TO: Milton Planning Board
FROM: Marion McEttrick *MM*
RE: 193 Central Avenue Site Plan and Landscaping Update
DATE: November 4, 2021

With this memo I am providing two updated sheets for the Site Plan for 193 Central Avenue, the Site Plan page and the Landscaping page, with changes requested at the last meeting.

THE GODDARD SCHOOL
193 CENTRAL AVENUE
MILTON, MASSACHUSETTS

SITE PLAN
(3 of 13)

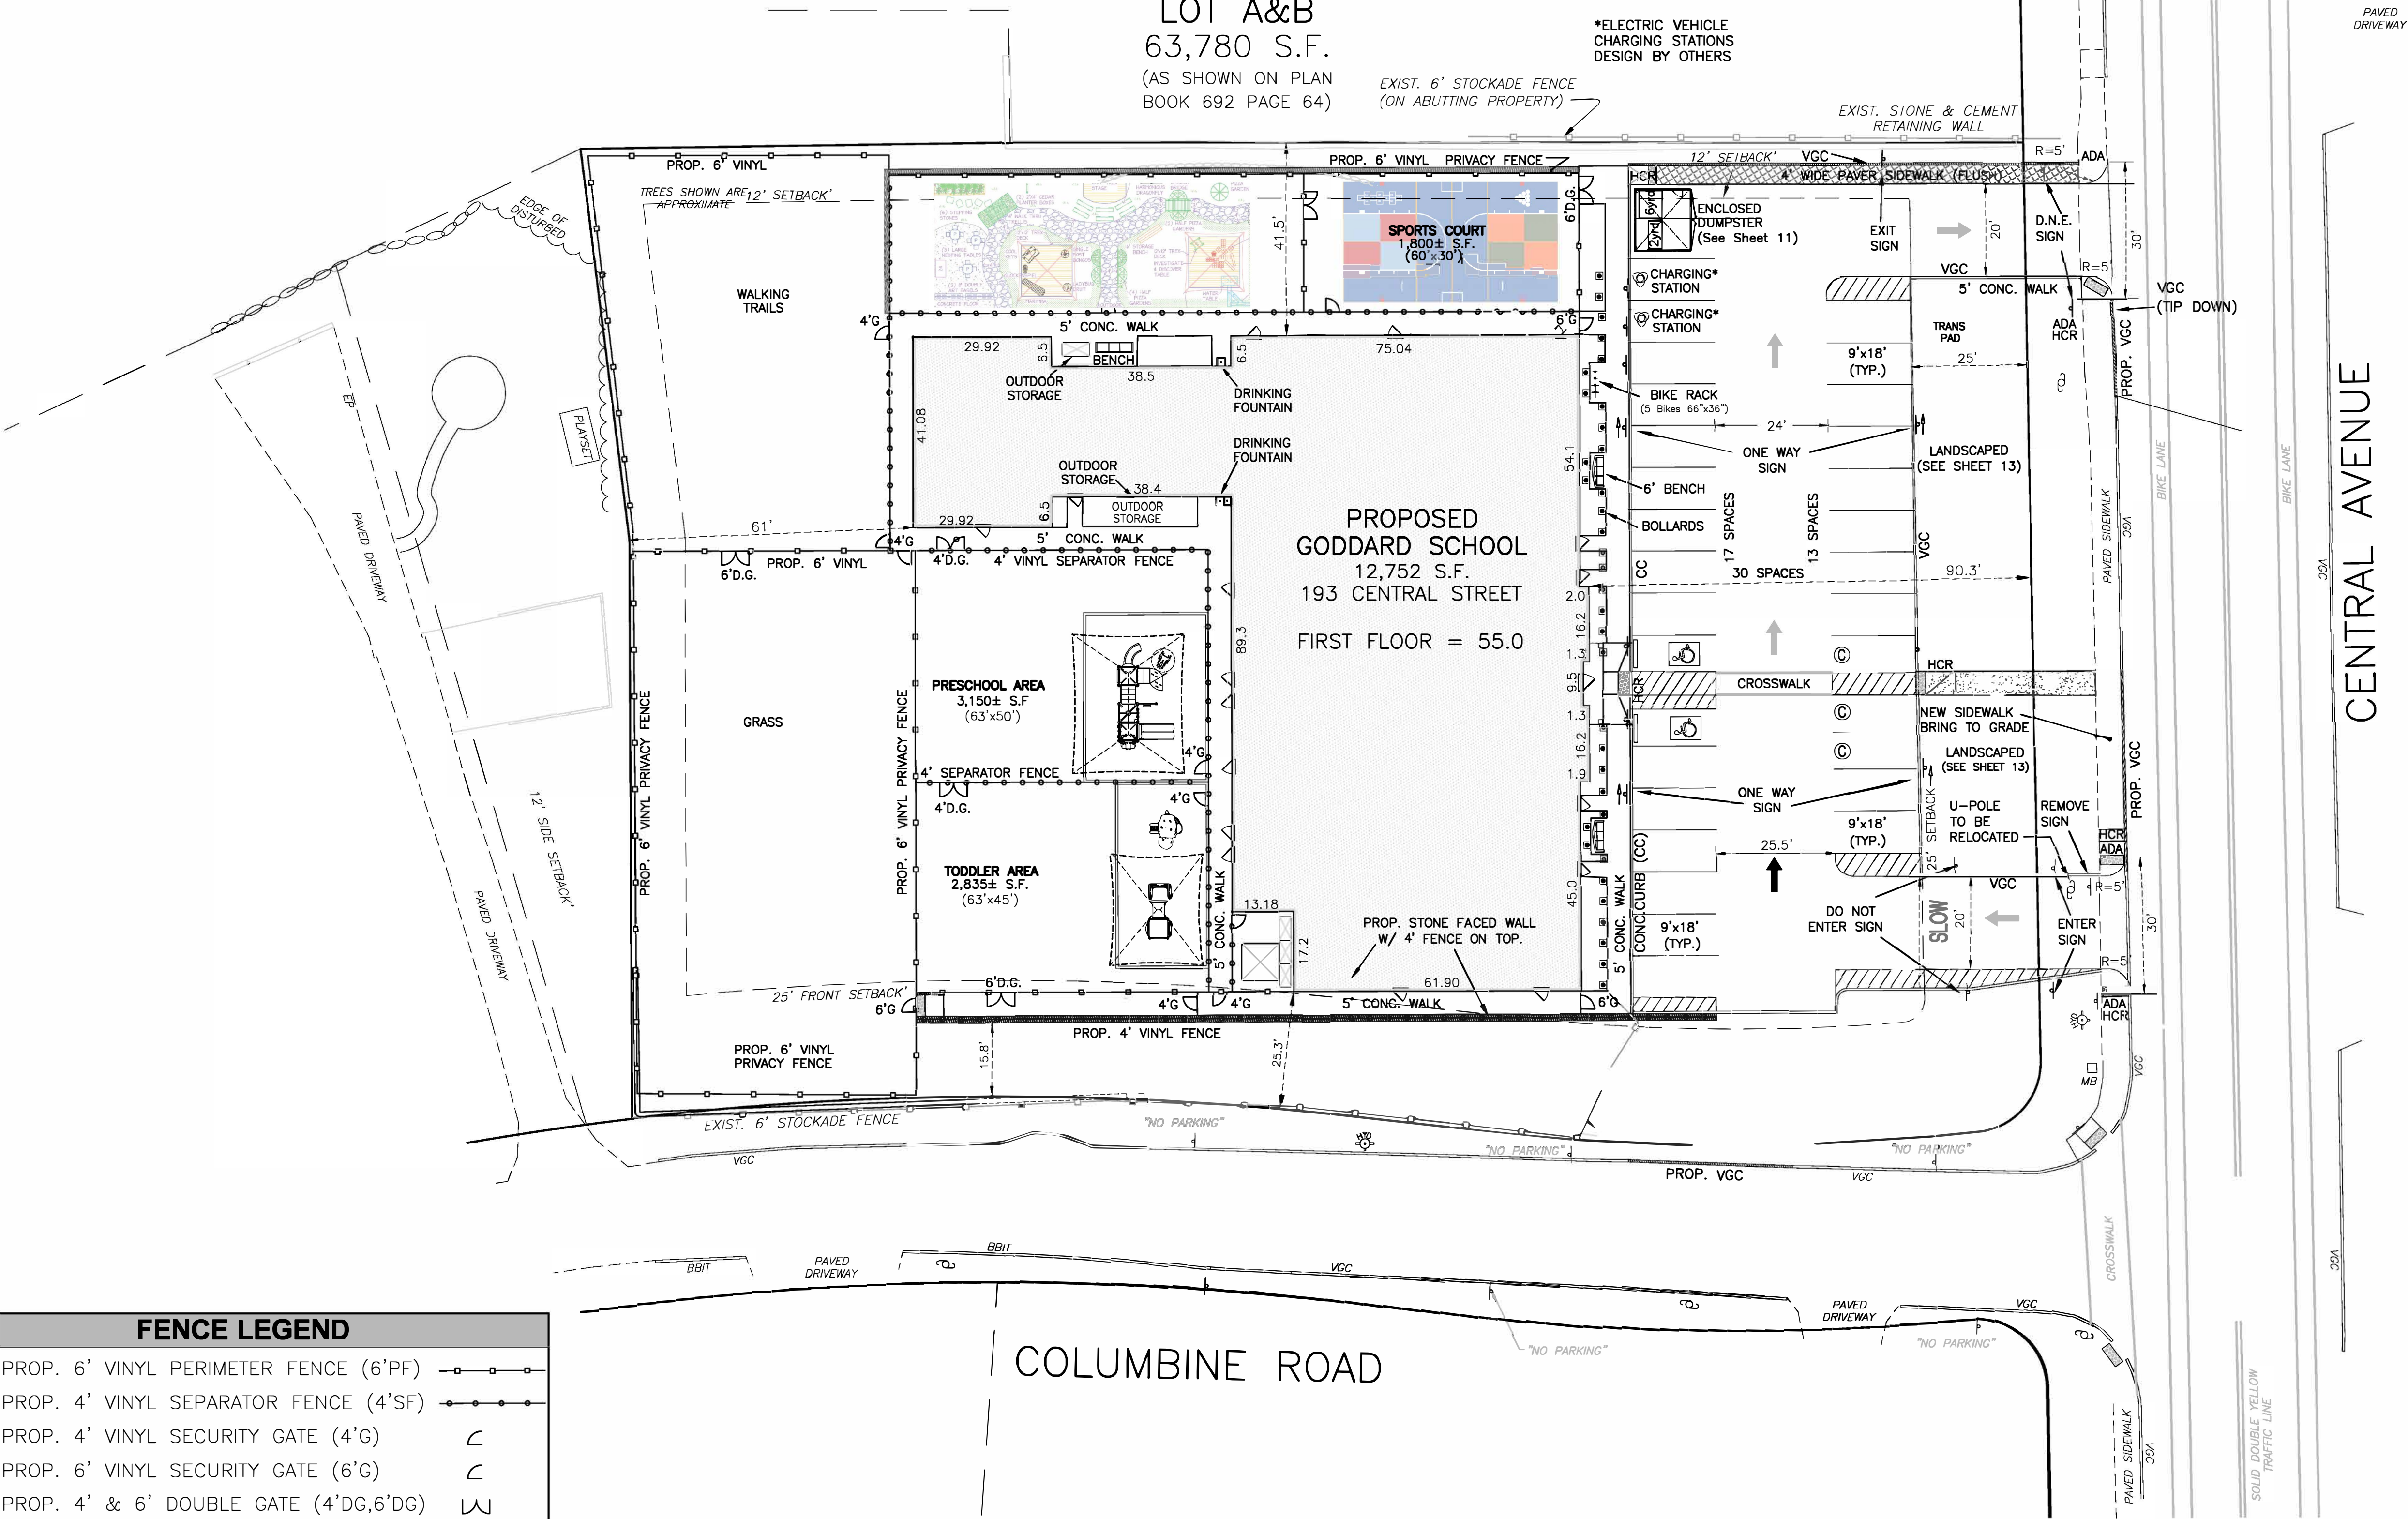
The changes to the Site Plan are:

1. The entrance has been moved over into the site approximately the width of one parking space.
2. One parking space has been removed.
3. The fence located starting from the stone-faced wall to the front lot line on the Columbine Road side has been removed. It is not required for safety. This allows for more snow storage area.
